WORLD WAR II MEMORIAL: FDR D-DAY PRAYER

PRESENTATION TO THE
COMMISSION OF FINE ARTS
(COMMEMORATIVE FEATURE DETAILS AND REVISIONS)

CFA 20/NOV/23-1

Drain Grate

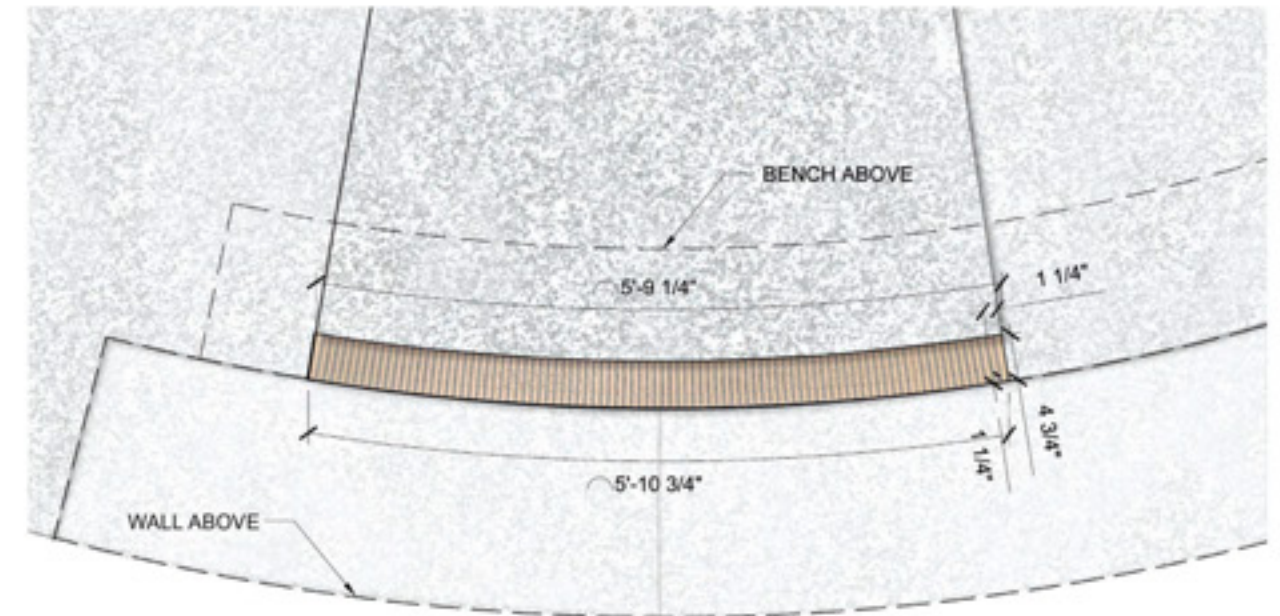
"...the Commission recommended that additional details be developed, [including], the possible **grading of the plaza** toward a slot drain located beneath the perimeter benches..."

- Drains are located to the east and west of the entry and under the plaque
- Drain grates are fabricated from bronze for durability

Semi-custom Bronze Grate (variable patina finish to be discrete beneath bench and plaque)

Detail - Bench Support

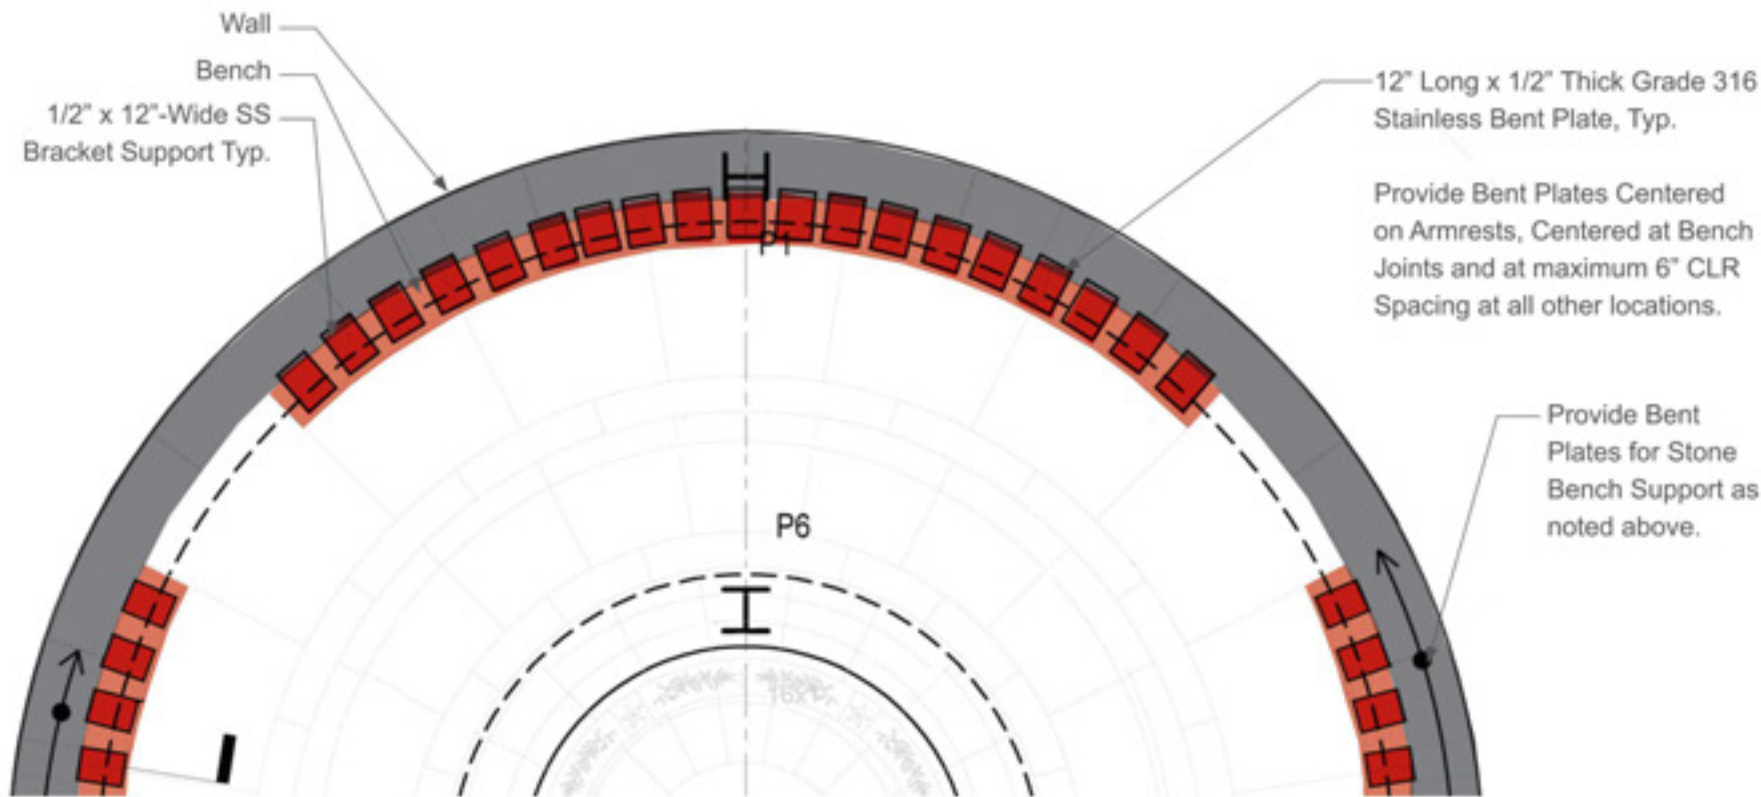
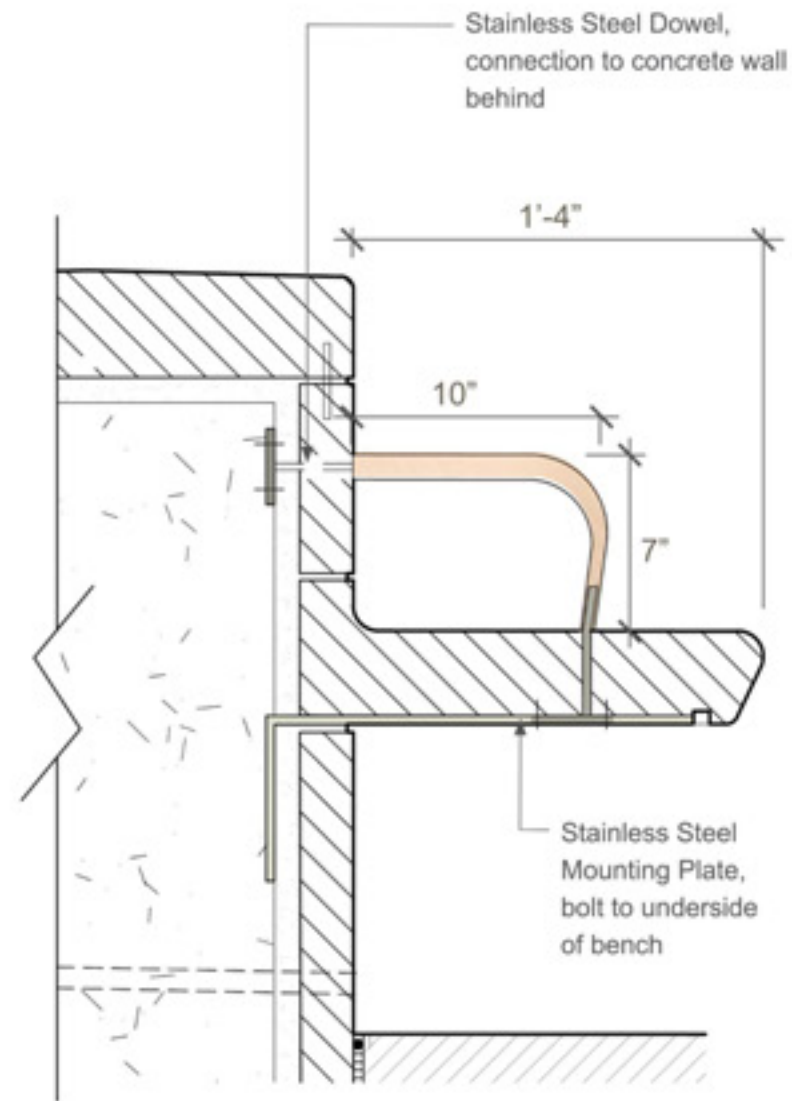
"...the Commission recommended that additional details be developed, [including], the design of any structural brackets required for the projecting benches..."

- Bench supports shall be stainless steel plates, inset into the bench stones
- Supports shall not be visible from above

Provide Shims as needed to ensure tight fit between Bent Plate and Curved Face of Concrete

(2) - 1/2" DIA. SS Hilti Kwik Bolt Anchor or Approved Equal @ 8" O.C.

Grade 316 SS Plate Per Plan
Coordinate Edge of Plate with Cove Light, See LA

Section

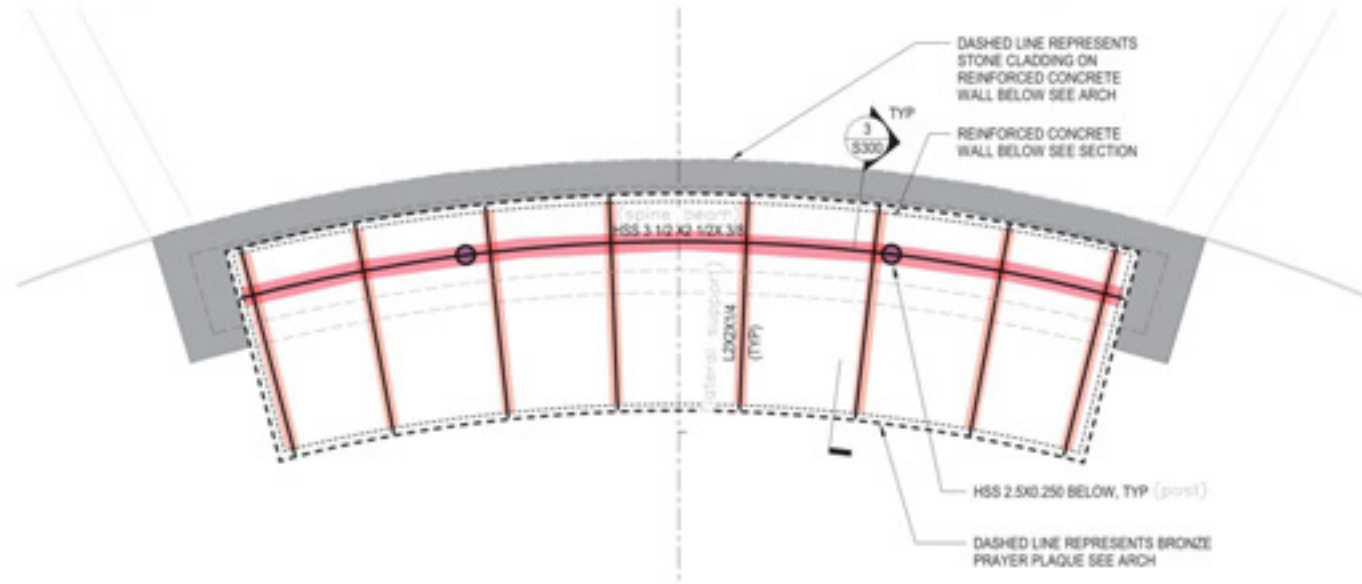
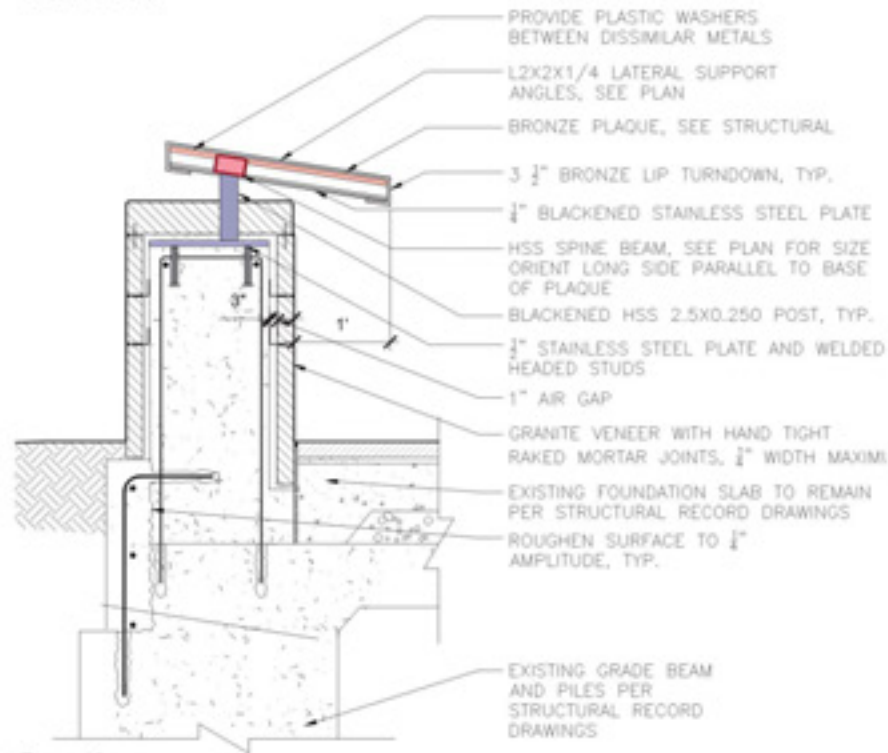
"...the Commission recommended that additional details be developed, [including], sufficient structural supports to prevent deformation of the **prayer plaque**..."

- Posts: 2-1/2" dia. x 1/4" thick SS hollow tube, welded to SS inbed plate in wall
- Spine: 3-1/2" x 2-1/2" SS hollow tube
- Lateral Supports: 2' x 2" x 1/4" SS plates
- Plaque supports shall be stainless steel and blackened to reduce visibility

Plan (current)

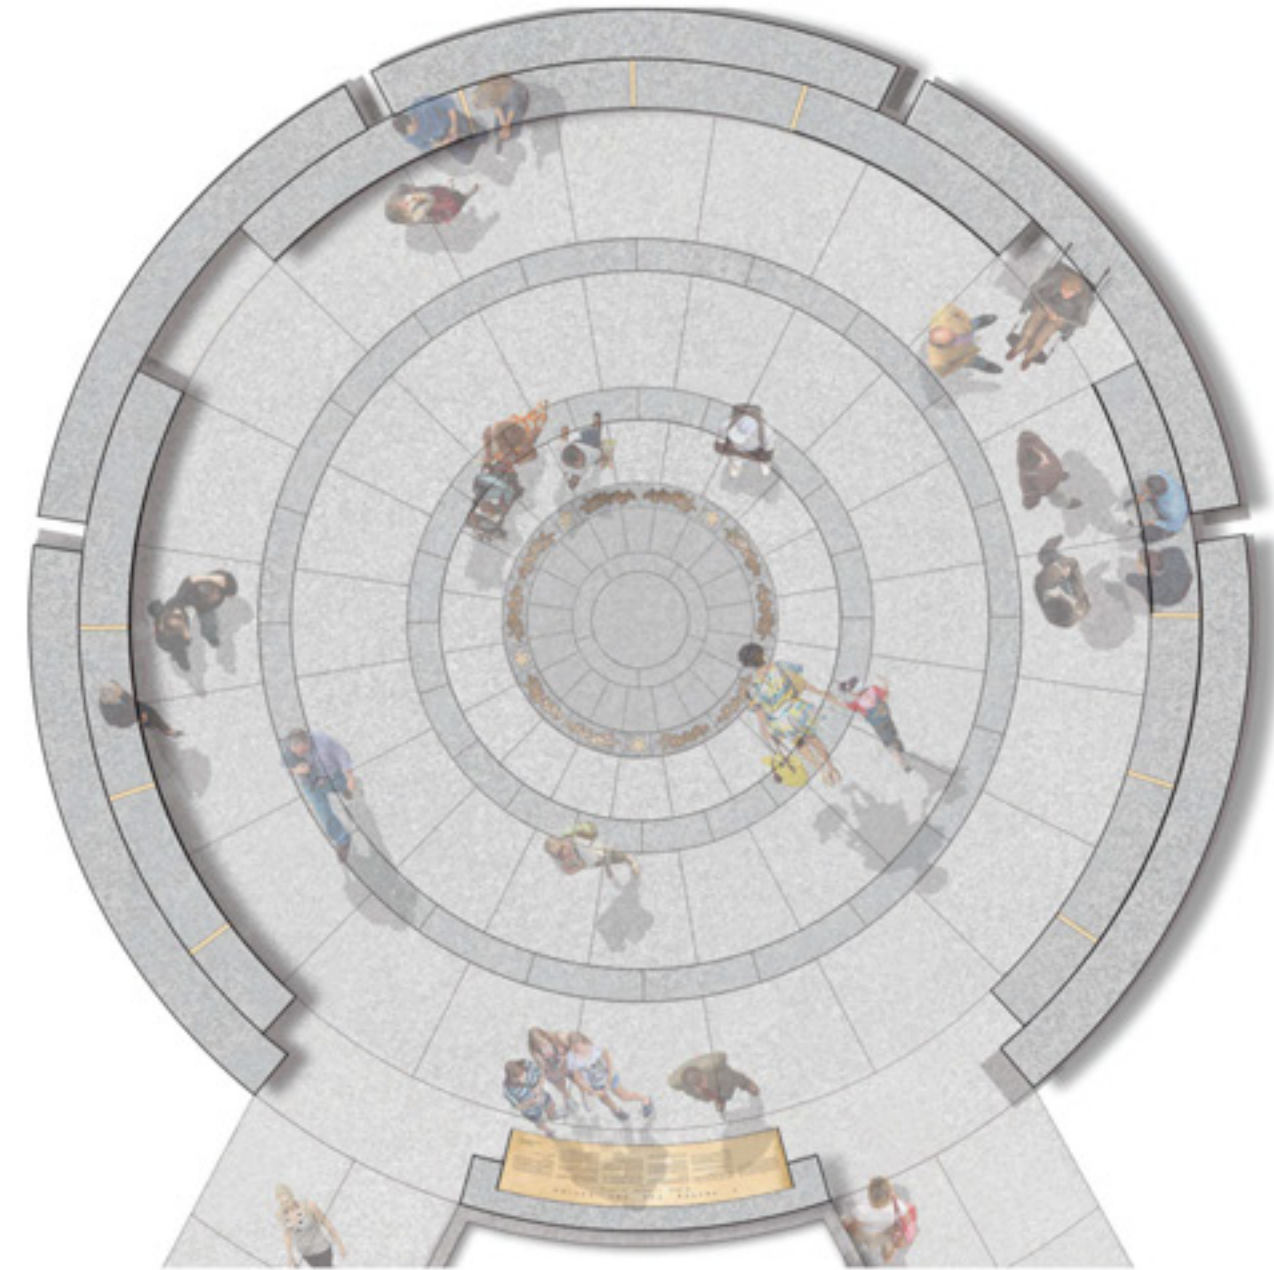
"...the Commission recommended that additional details be developed, [including], the design for the composition of the **medallion and garland** within the pavement..."

"In their discussion of the option for a bronze medallion at the center, intended to repeat the Victory Medal design in the arches of the World War II Memorial, some Commission members raised concern that the figural composition would create an undesirable directionality to the space and would detract from the importance of the prayer plaque, while others found that the medallion as proposed has strong symbolic importance and reinforces the connection to the main part of the memorial; the Commission concluded by recommending a design featuring both the garland and the medallion." *CFA Letter May 27, 2021*

Plan (enlarged garland and star)

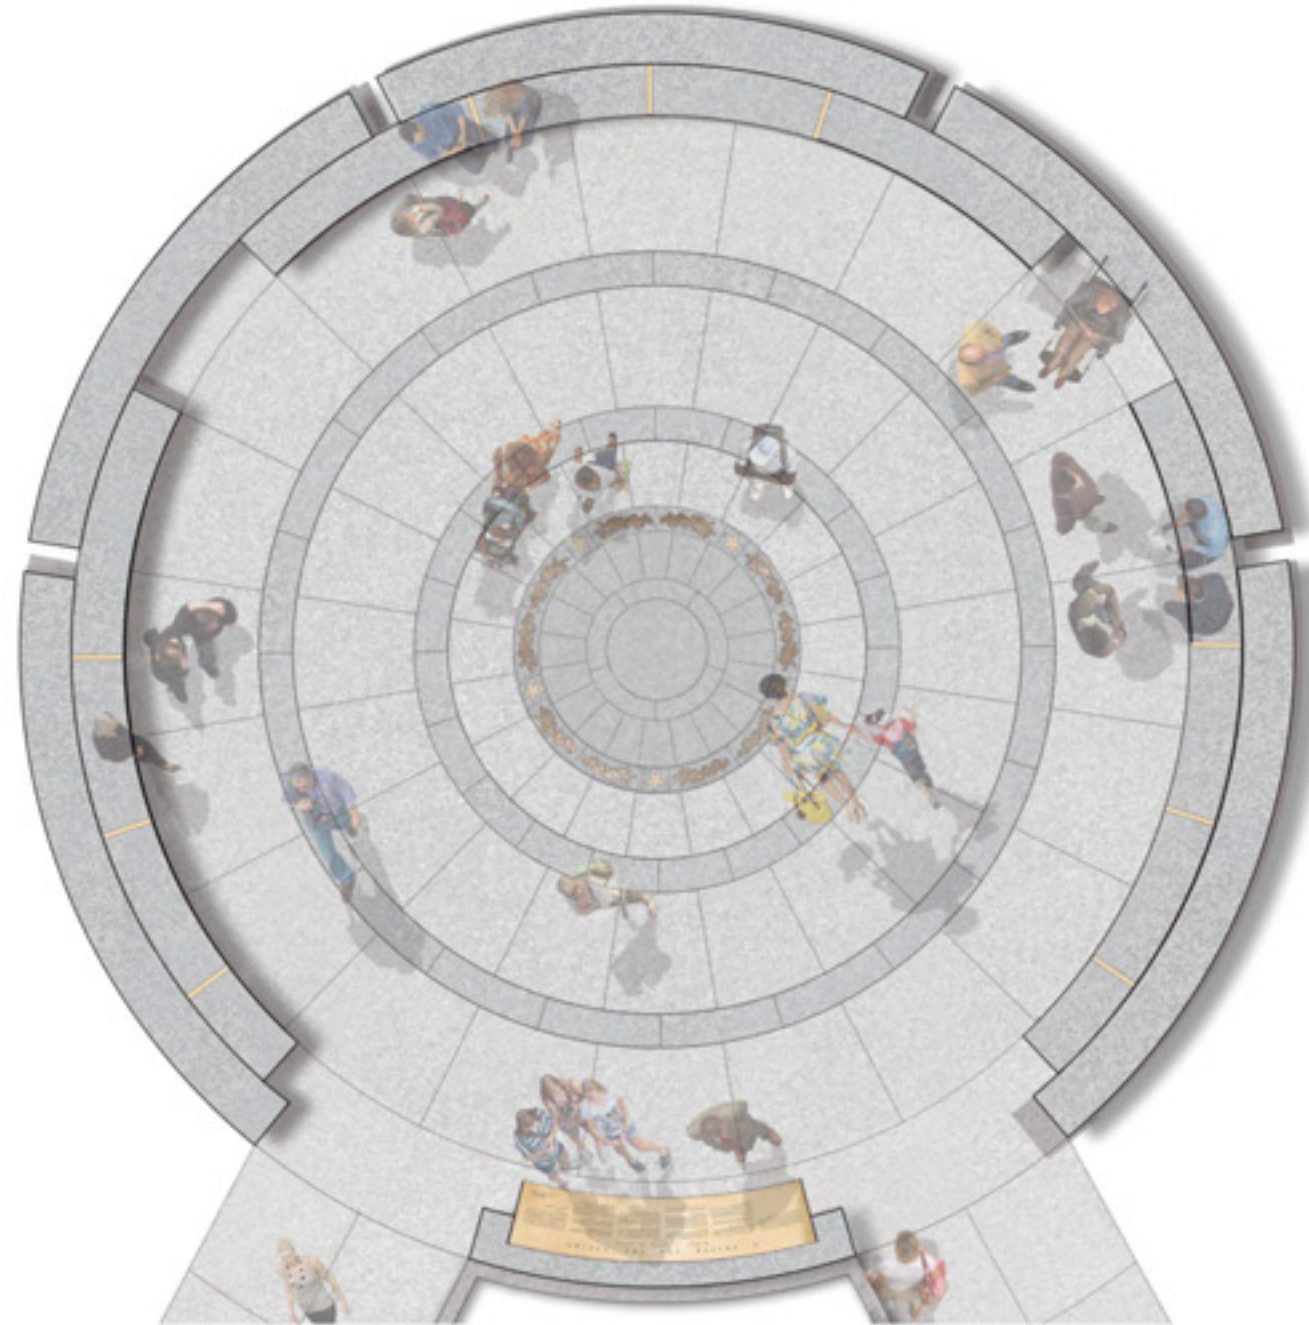
"...the Commission recommended that additional details be developed, [including], the design for the composition of the **medallion and garland** within the pavement..."

"Concerning the options presented for the center of the pavement within the circle, the Commission members unanimously endorsed the inclusion of the circular garland design of olive branches and five stars, suggesting that this element could be made bolder, possibly larger or located in an inner ring of the pavement; to enhance the clarity of this design, they recommended that the elements of the garland be bronze inset into the granite paving stones instead of cast as bronze panels." *CFA Letter May 27, 2021*

Plan
scale: NTS

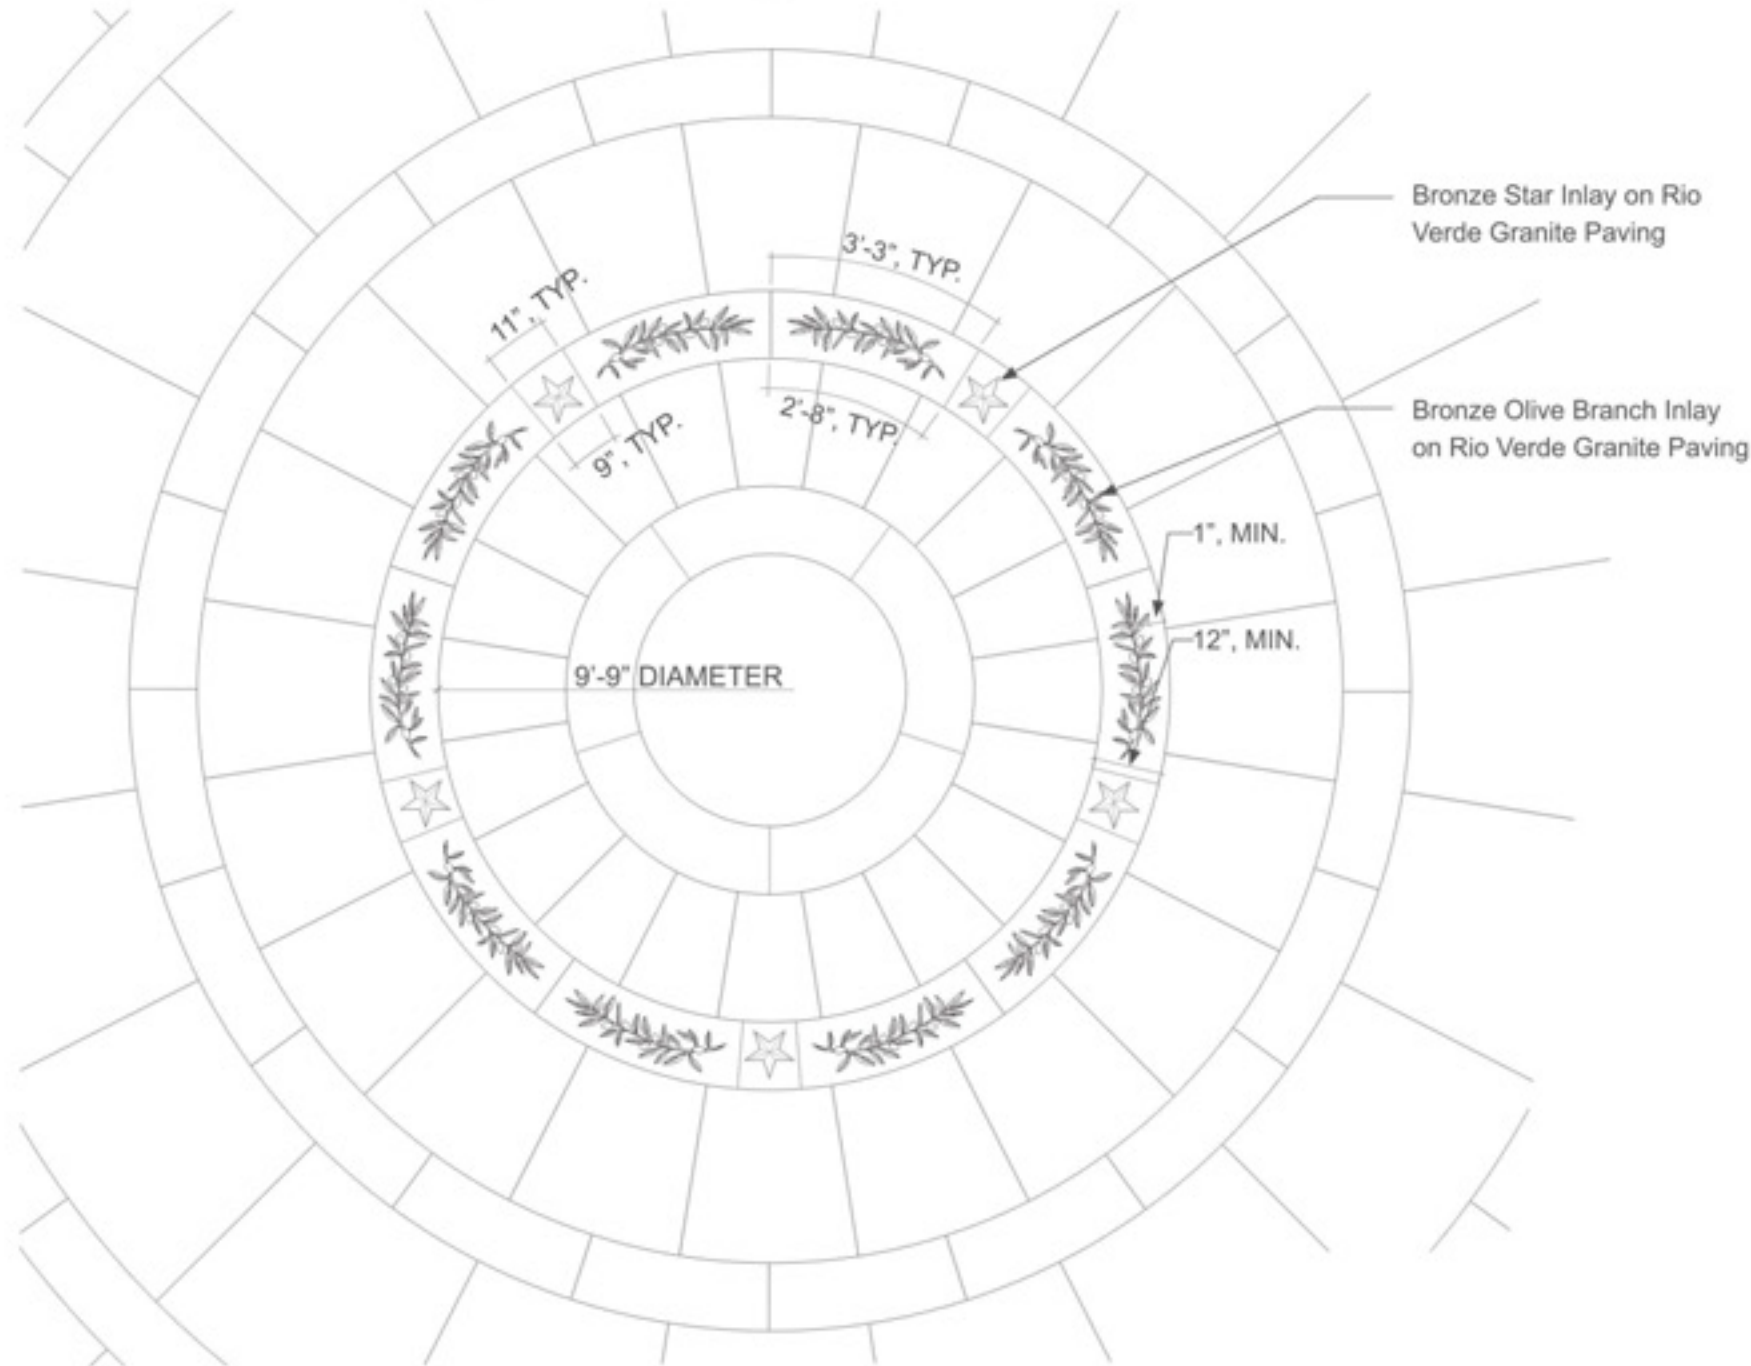
"...the Commission recommended that additional details be developed, [including], the design for the composition of the **medallion and garland** within the pavement..."

- Bronze stars and olive branches to be inset in granite paving band
- Olive garland is botanically inspired, rather than stylized
